# **Coalbed Methane Stream Depletion Assessment Study – Northern San Juan Basin, Colorado**

**State of Colorado Department of Natural Resources,  
Division of Water Resources and the Colorado Oil  
and Gas Conservation Commission**

**S.S. PAPADOPULOS & ASSOCIATES, INC.  
Boulder, Colorado**

The report dated February 2006 prepared by S.S. Papadopoulos & Associates, Inc. is provided for public review and comment. This study was a joint effort by the Colorado Oil and Gas Conservation Commission (“COGCC”), the Colorado Geological Survey (“CGS”) and the State Engineer’s Office Division of Water Resources (“DWR”). These agencies are part of the Colorado Department of Natural Resources (“DNR”).

Figure 2.1. Annual Precipitation on the Fruitland Formation Outcrop, Northern San Juan Basin

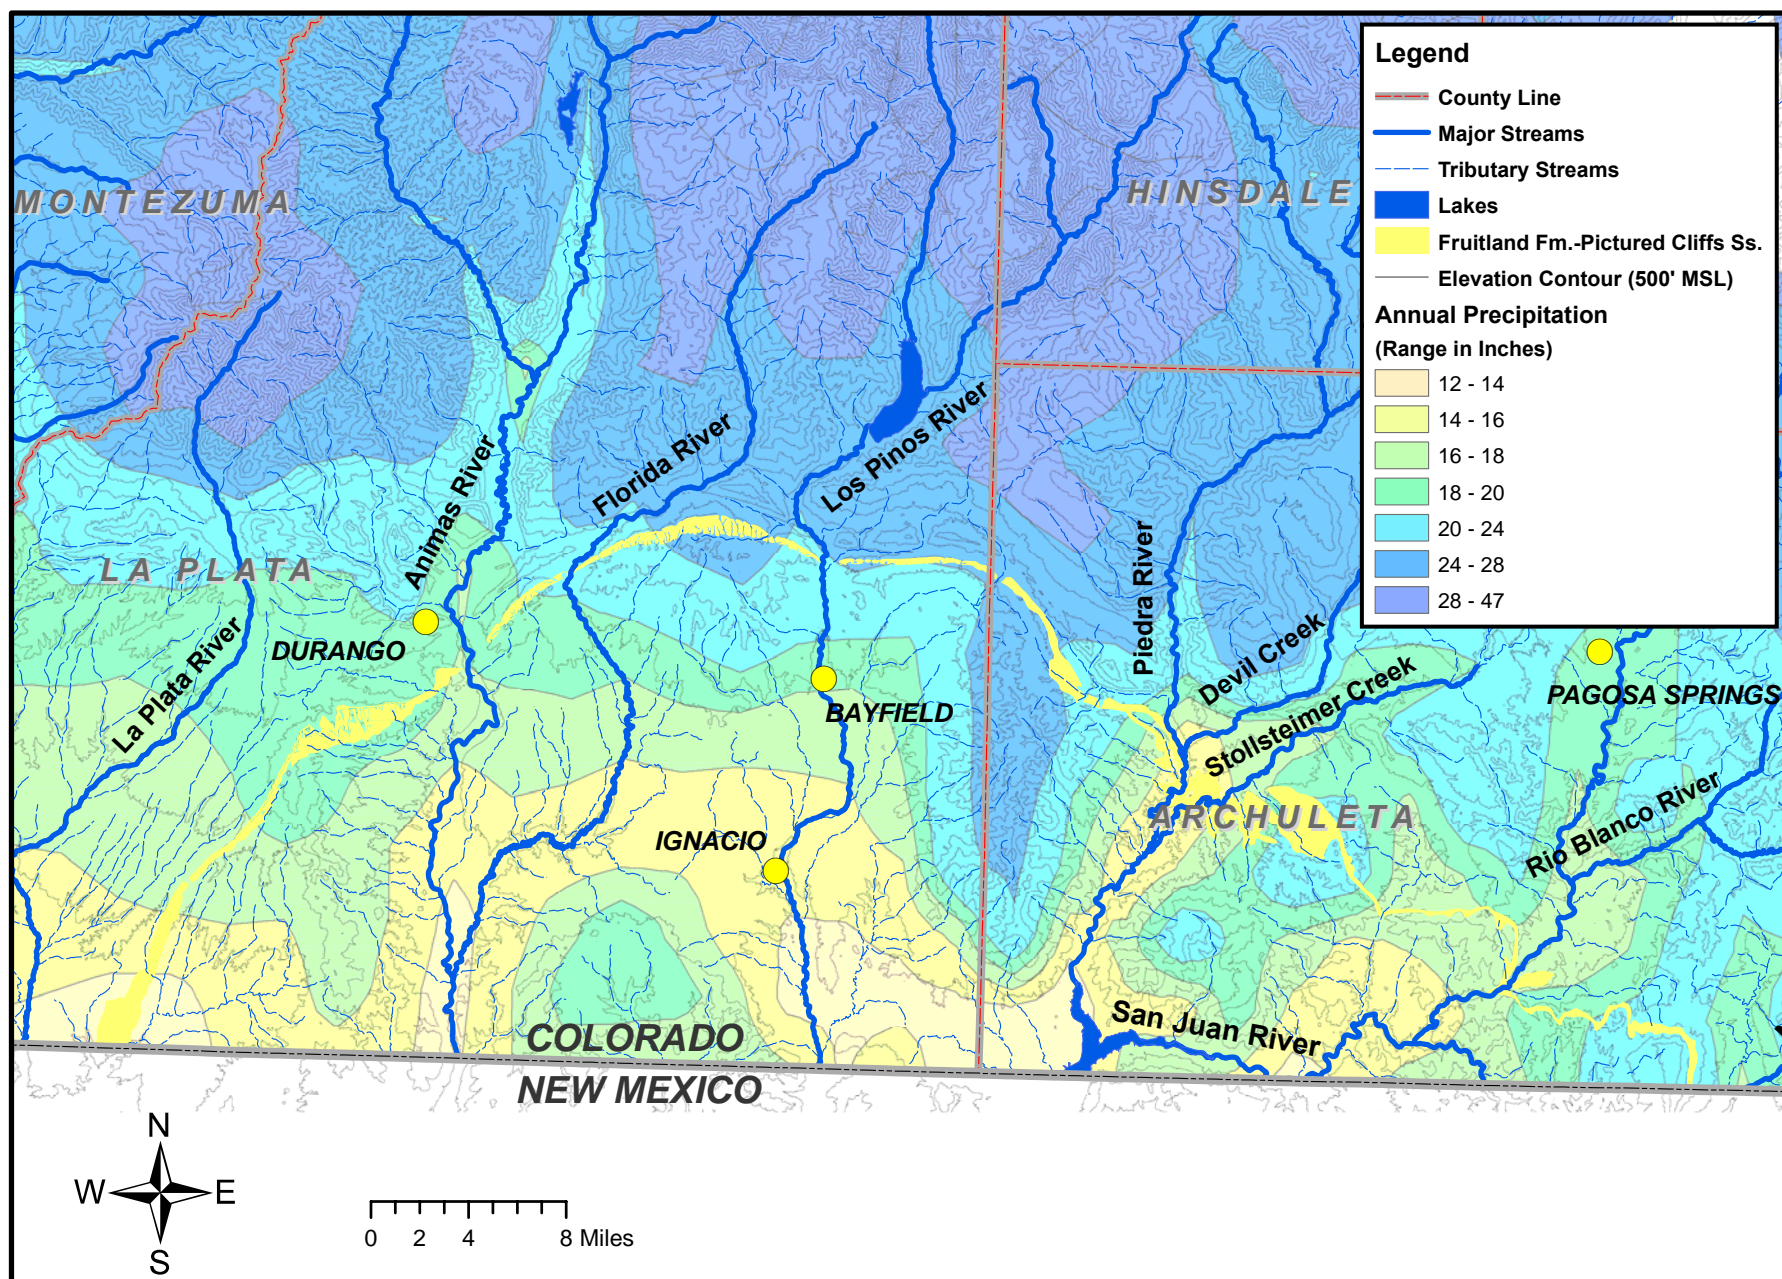
23. Page 50, 3<sup>rd</sup> Paragraph, Last Sentence – An obvious exception to this is the Pine River Ranches data, which should be noted.
24. Figure 2.1 – Untitled with no source reference.

24. Figure 2.1: Outcrop is a compilation from published geologic maps – Carroll et al., 1997; Carroll et al., 1998; Carroll et al., 1999; Carroll and Tremain-Ambrose, 1998; Steven et al., 1974; Wray, 2000. Precipitation information comes from CGS GIS data set used in the Ground Water Atlas of Colorado (Topper et al., 2003)

Figure 2.2. Stream Systems and Major Drainage Basins of the Northern San Jan Basins

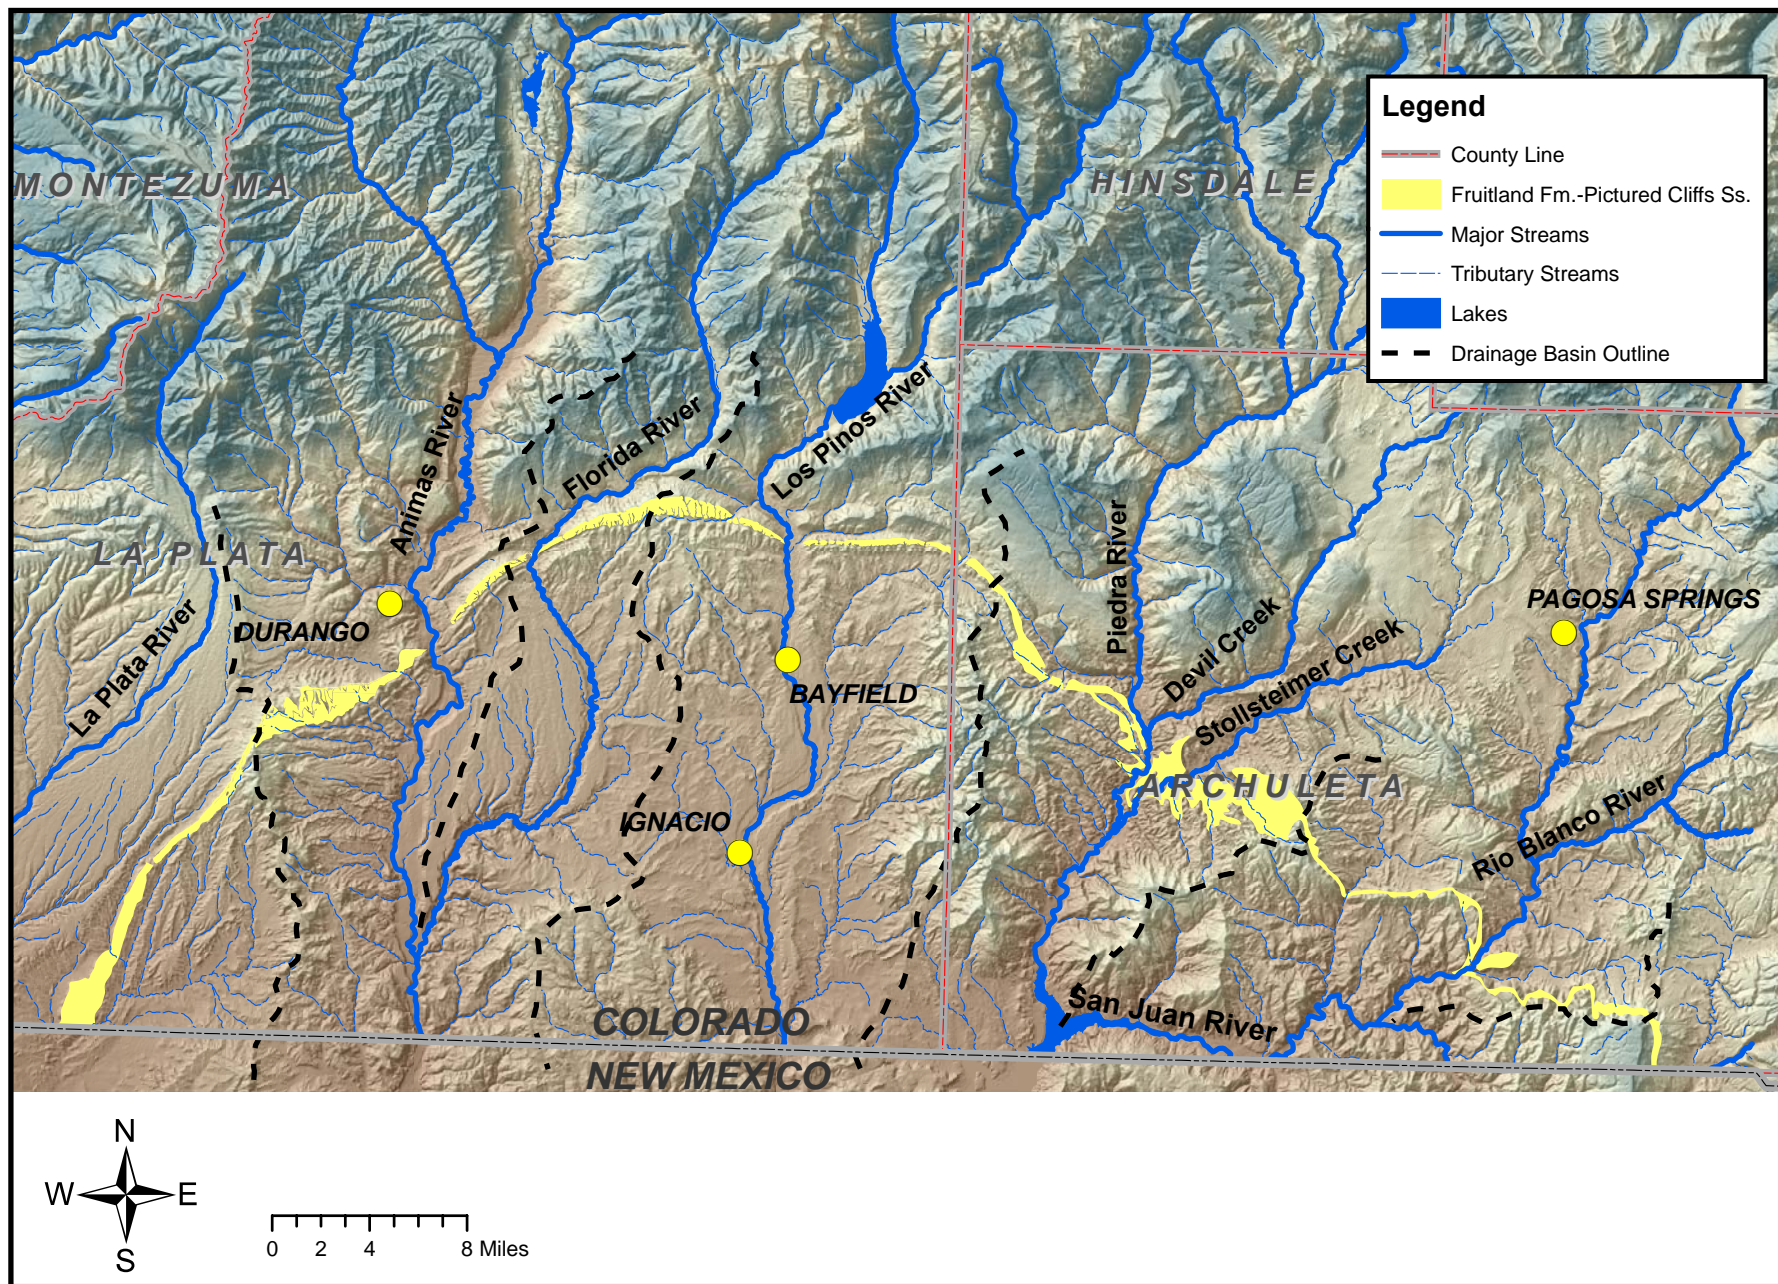
25. Figure 2.2 – Untitled with no source reference.
26. Figure 3.1 – The source of this information should be cited.
27. Figure 3.3 – Untitled with no source reference.

25. Figure 2.2: Outcrop is a compilation from published geologic maps – Carroll et al., 1997; Carroll et al., 1998; Carroll et al., 1999; Carroll and Tremain-Ambrose, 1998; Steven et al., 1974; Wray, 2000. The drainage basin divides were determined by CGS for this figure.

**Figure 3.5.**  
**San Juan Basin Structural Hingeline**

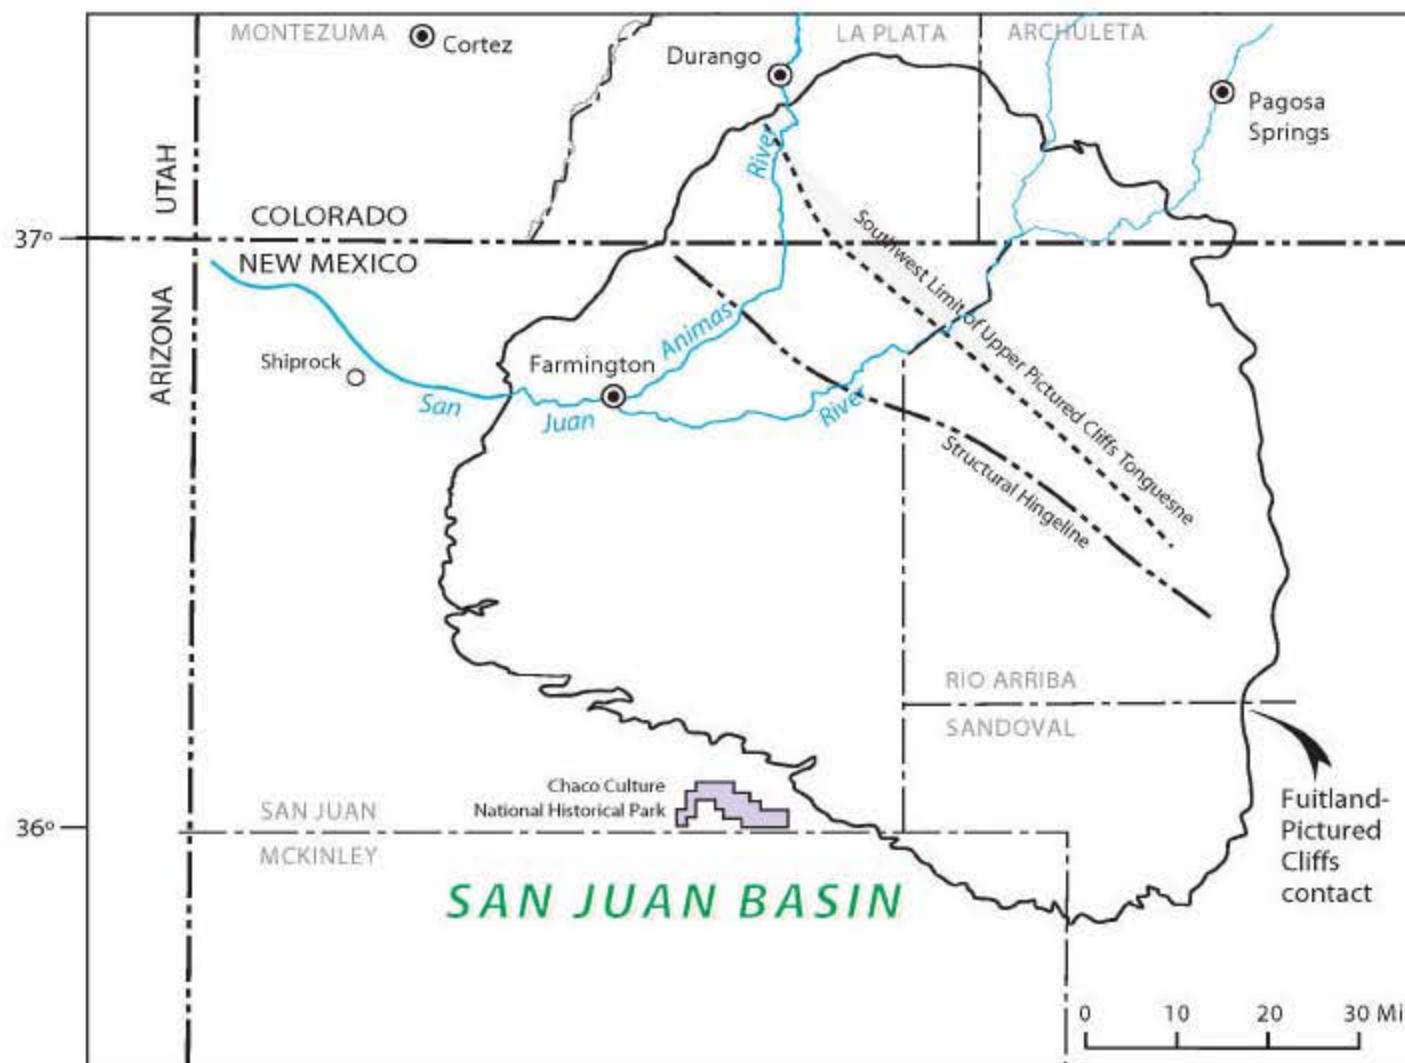
28. Figure 3.5 – The source of this information should be cited.
29. Figure 3.6 – Untitled with no source reference.
30. Figure 3.7 – Untitled with no source reference.

28. Figure 3.5: Reference used was Ayers et al., 1994 (originally from Ayers and Ambrose, 1990).
- 29 and 30. Figures 3.6 and 3.7: Compiled by CGS from Condon, 1997; Tremain et al., 1994; and from geologic maps Carroll et al., 1997; Carroll et al., 1998; Carroll et al., 1999.

Figure 3.8. □

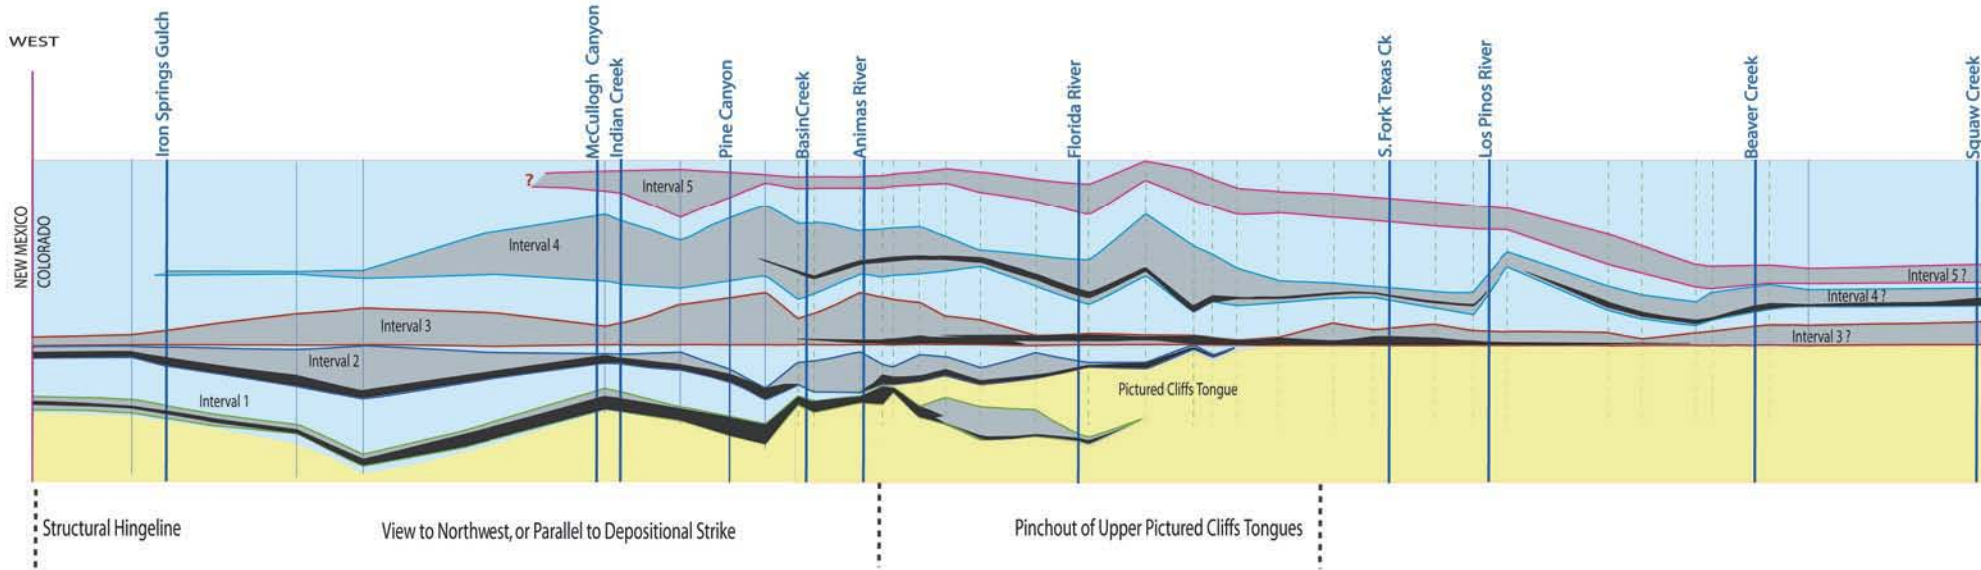
31. Figure 3.8 – No figure number.
32. Figure 5.1 – The general location of this cross section (and others) should be provided on one of the planimetric maps.

Figure 5.2. Fruitland-Pictured Cliffs Aquifer Potentiometric-Surface Map

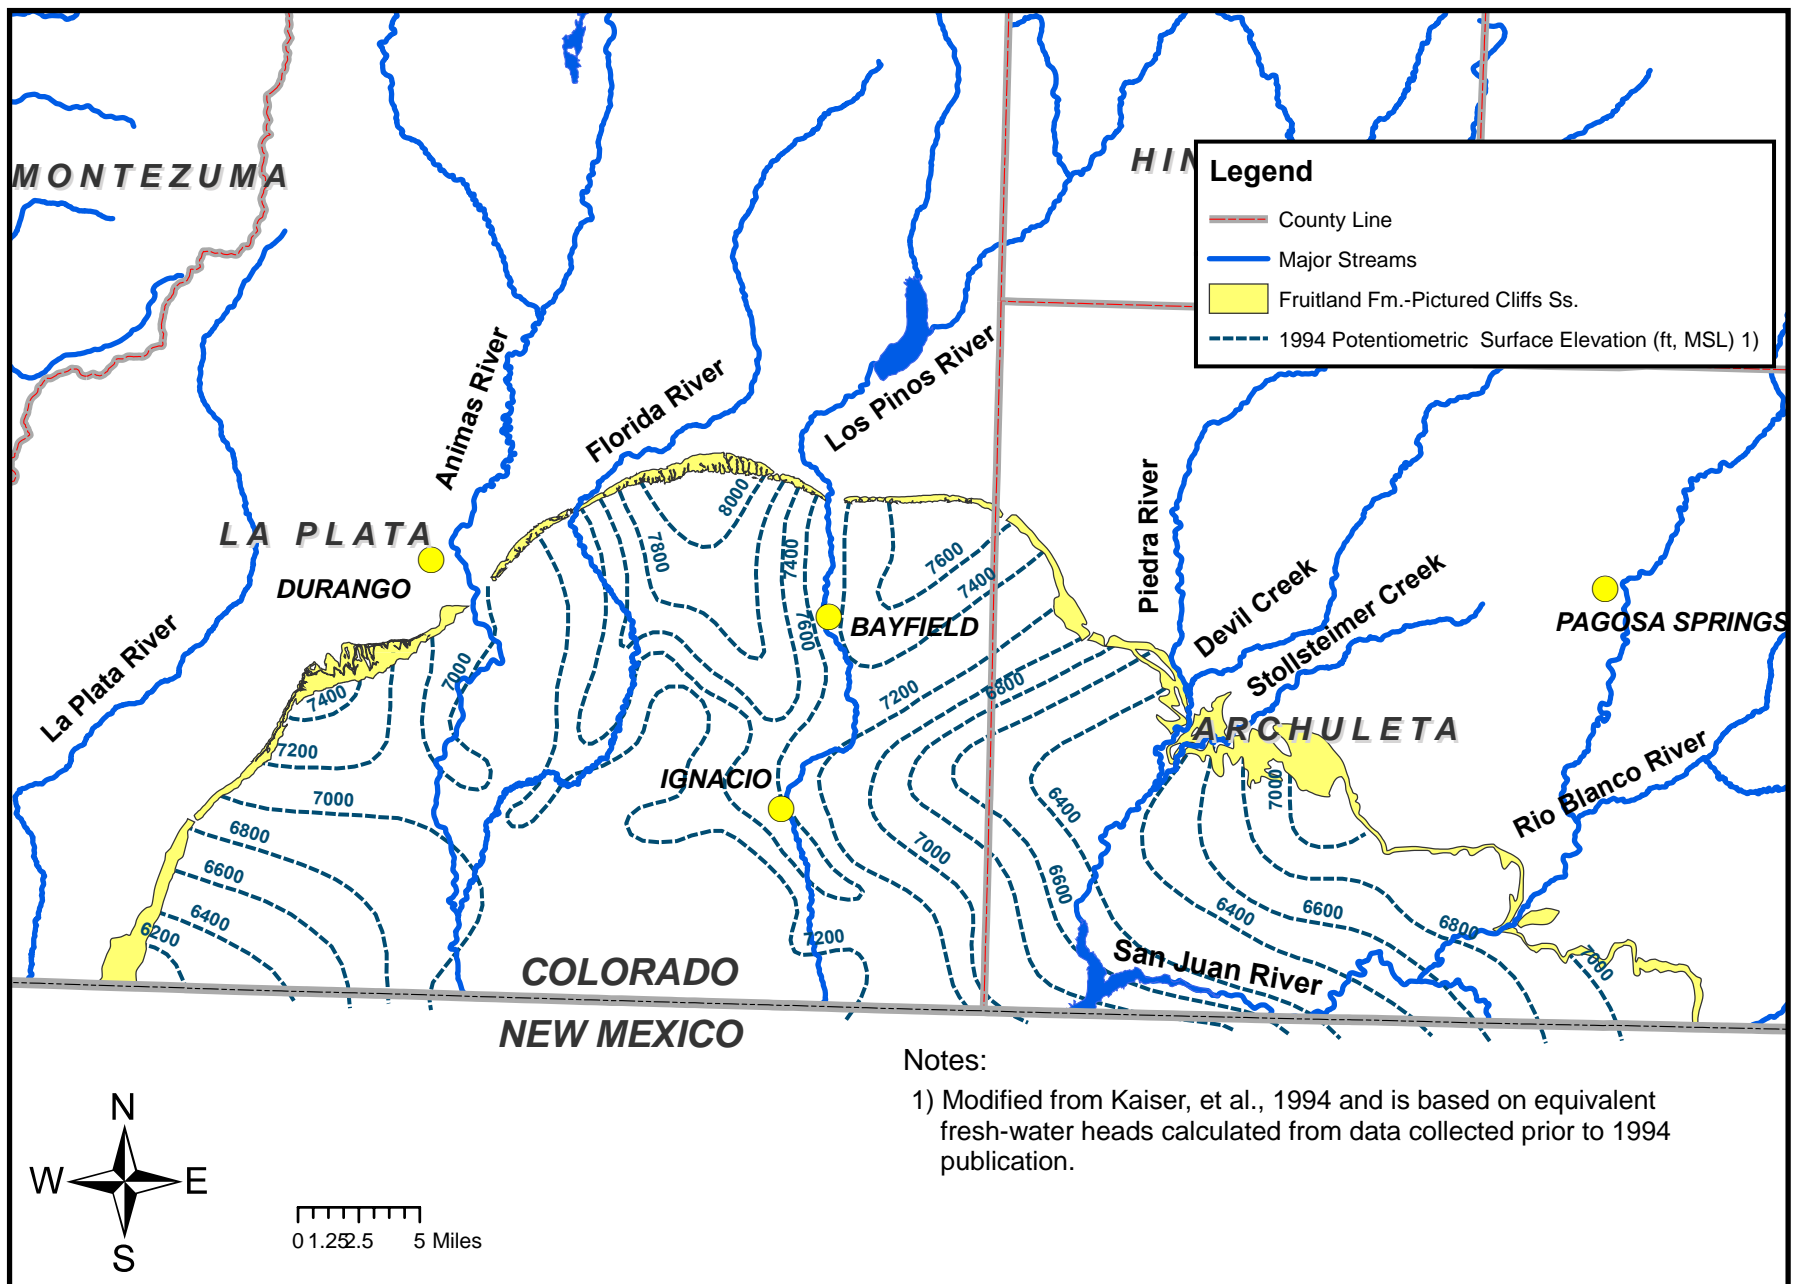
33. Figure 5.2 – Untitled.
34. Figure 5.5 – If one assumes that downbasin production is draining the Fruitland Formation, then spring flows at the highest elevations of the outcrop should be greatly diminished or nonexistent. Perhaps the existence of these springs (as indicated on this figure) is an indication of a lack of downbasin connectivity.

11. In evaluating changes in potentiometric heads in the basin over time, the maps of Berry and McCord were reviewed. The Kaiser et al. (1994) map was chosen for use in the report (Figure 5.2) because it both includes more data points than the two other maps and is still illustrative of conditions in the basin prior to significant CBM production. More importantly, comparisons between Figures 5.2 and 5.6 allow transient pressure changes from existing wells in response to CBM production to be examined.
